Proposed Development: Proposed residential development for the erection of up to four dwellings

Site Address: Land to rear of 1-19 Colenso Road, Blackburn, BB1 8DR

1.0 SUMMARY OF RECOMMENDATION

Figure Four – Photo showing access arrangements

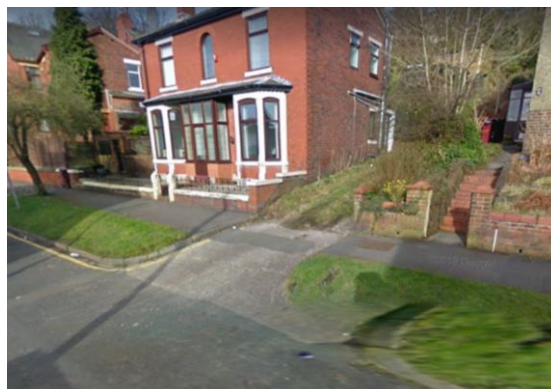
4.4.3 A need for two-way traffic movement has been identified in the comments provided by BwD Highways alongside a footway for pedestrian/cyclist movements. Although access is a reserved matter at this stage, the existing access point is the only realistic point of entry for vehicles. The majority of pedestrian/cyclist movements would also likely be gained from that point. The existing access point measures circa 3m in width and it is clear the request from BwD Highways cannot be provided. That said, they have acknowledged that sightlines are clear and short walls around 1m in height currently stagger the access point. Whilst vegetation in the front gardens of 7 and 9 Colenso Road could have the potential to reduce visibility in the future, reasonable visibility would always be maintained at the carriageway edge given the presence of a grass verge between the access point and carriageway edge, which is shown below in Figure Four.

For the number of houses proposed, a minimum of 2way movement is needed; No area to safeguard pedestrian from vehicles, as they travel from the highway to the properties is achievable; Sightlines although clear, could become restricted by frontage boundary treatment of the houses sited adjacent to the track; Access Road is inadequate to support the development; No off street parking arrangements submitted; The Council's Cleansing team have also objected to the proposal given the fact a refuse collection vehicle is unlikely to be able to access and manoeuvre out of the site, and ;Each property would have to take their bins to Colenso Road for collection, which may cause implications for access and blocking pavements.

The current outline application has reduced the number of proposed dwellings to four, three bedroom detached houses and provided for a passing bay at the top of the shared access with No.7 Colenso Road to facilitate single way movement, but no plans detailing the proposed access road, cul-de-sac, driveway accesses and layouts of the proposed dwellings.
